Figure 7-1. MOU (7-mm × 7-mm) Pinout, 0.5-mm Pitch (Top View)

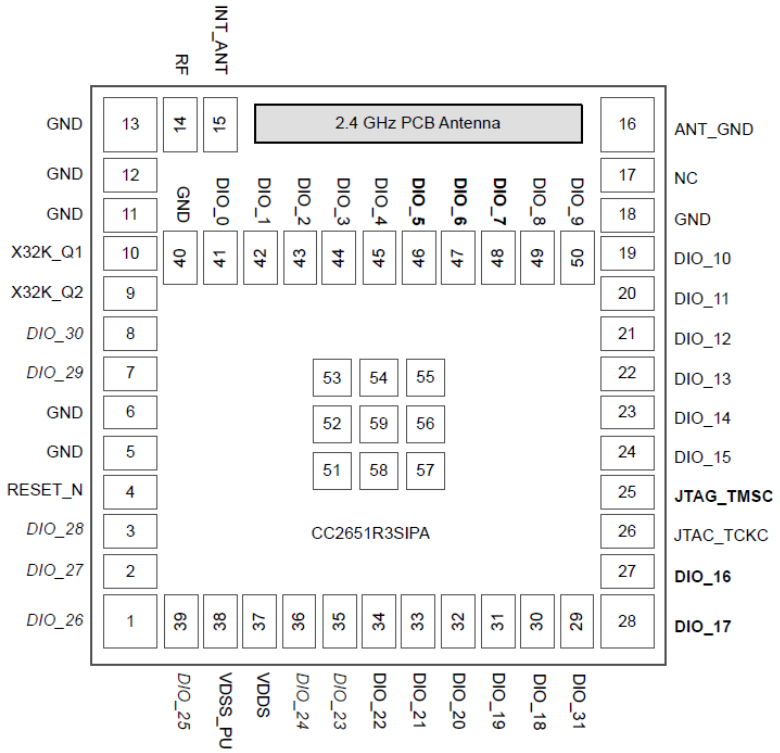
Page 7, supposed to be top view and coherent with the samacsys footprint:

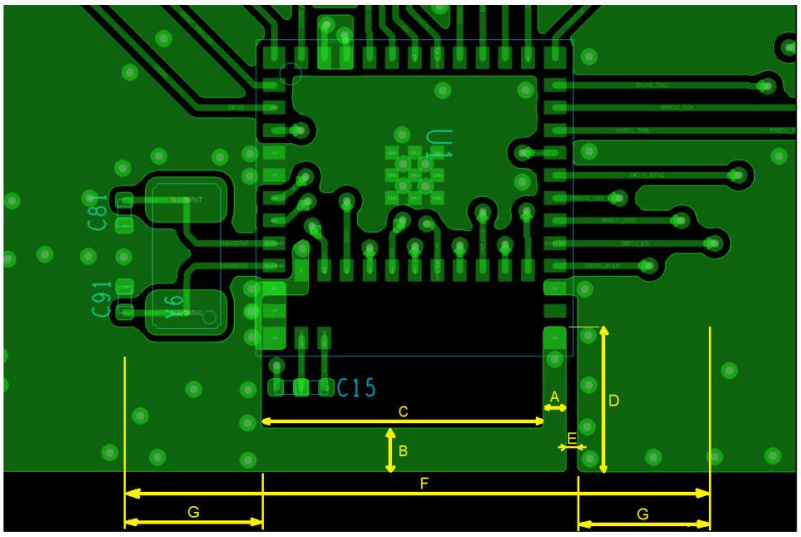
Page 50. Supposed to be top view (mirrored from page 7):

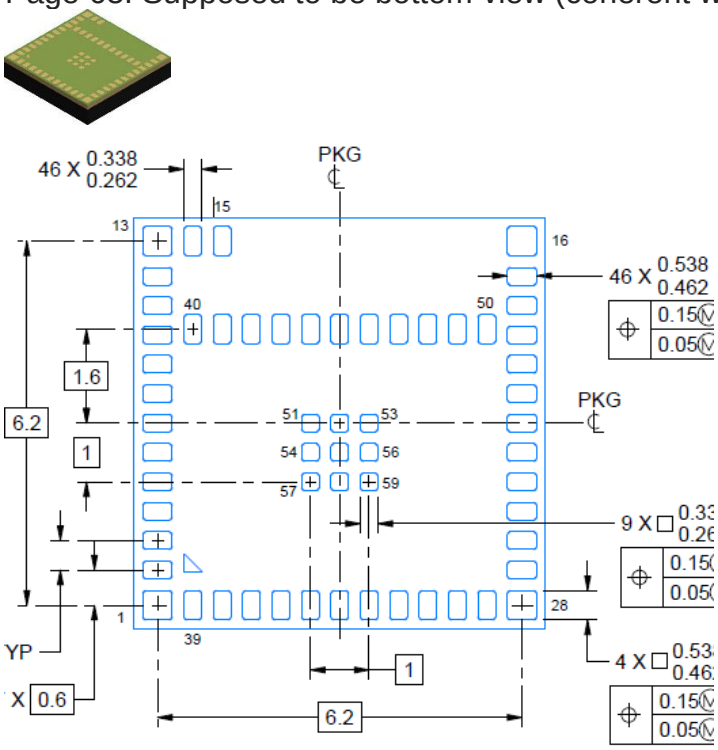
Page 65. Supposed to be bottom view (coherent with page 50):

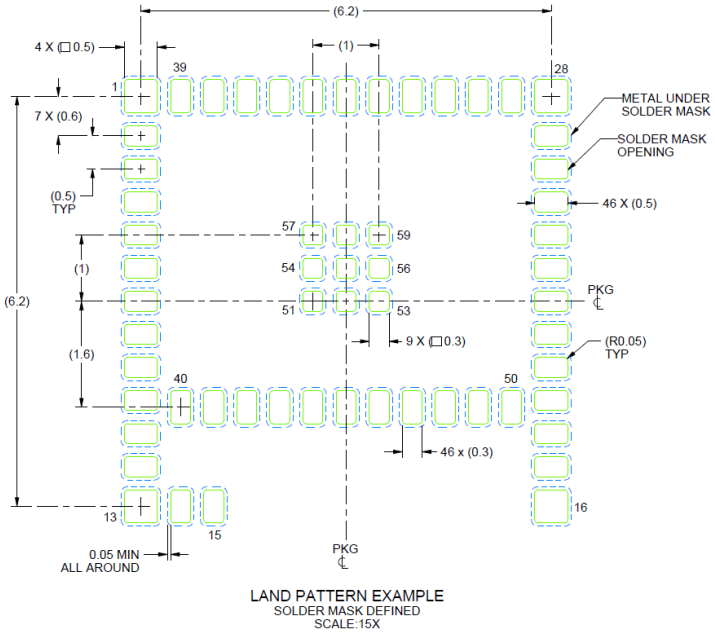
Page 66. Supposed to be TOP view (coherent with pages 50, 65 and 67 - Mirrored from page 7):
